**Annexure I Road Safety Audit (Pedestrian and Cyclist
Detour Routes)**

VRE Pedestrian and Cyclist Routes Pre-Construction Strategic Design Road Safety Audit

Client: JHCPB

Date: 18 December 2019

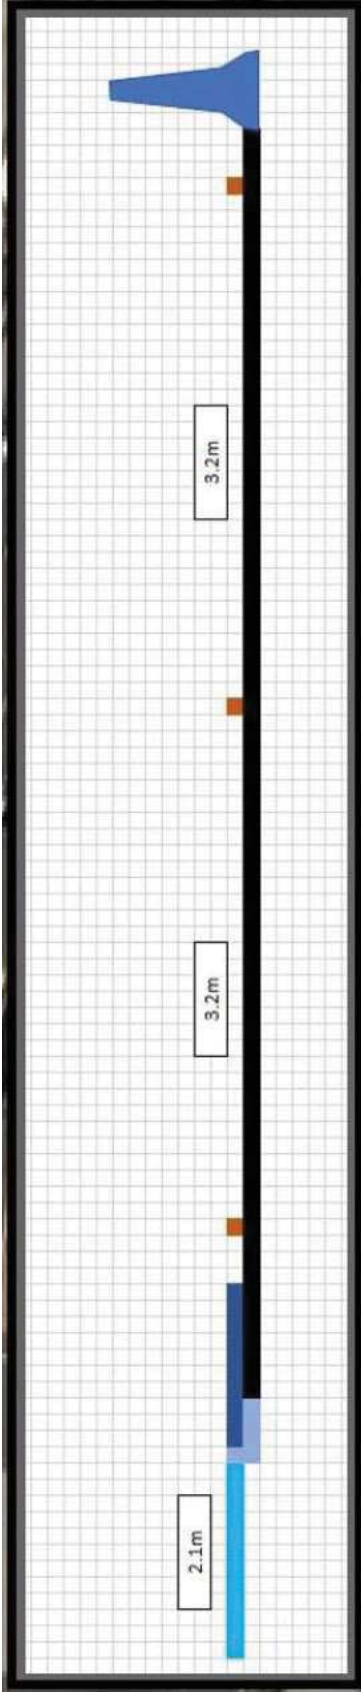
Item No.	Location / Time Period	Descriptions of Findings	Design/ Photo	Likelihood	Severity	Risk Rating	Designer Response
1.	Victoria Road south of Robert Street March 2020 – March 2023	Once the bridge is removed the cyclist desire line will still be to cross Victoria Road south of Robert Street. There is a risk of a cyclist being struck by a vehicle if they attempt to cross at this location due to the width of the road and traffic volumes. This would result in serious injuries to cyclists. The proposed detour route on Gordon Street has unfavourable gradient and additional delays crossing Victoria Road as well as the additional distance.		Occasional	Serious	High	Agreed. Temporary pedestrian fencing will be installed in those locations where existing fencing / barriers are not present to prevent any mid-block attempts for crossing Victoria Road
2	Shared path junction on western approach to Anzac Bridge August 2020 – March 2023	The raised garden bed may obstruct sight distance between cyclists and pedestrians approaching from the detour and the route parallel to the Anzac Bridge approach. The vegetation has died back at the moment but could grow to obstruct sight distance. The number of conflicting movements at this junction will increase significantly when detours are in place. This may lead to a collision between cyclists and pedestrians causing injury. As observed in the commuter peak periods, cyclists travel on Anzac Bridge with speed which heightens the severity of potential collisions when there is most pedestrian movement.	 	Occasional	Moderate	Medium	Noted. The company will monitor this vegetation to ensure it does not impede sight distance between pedestrians and cyclists.
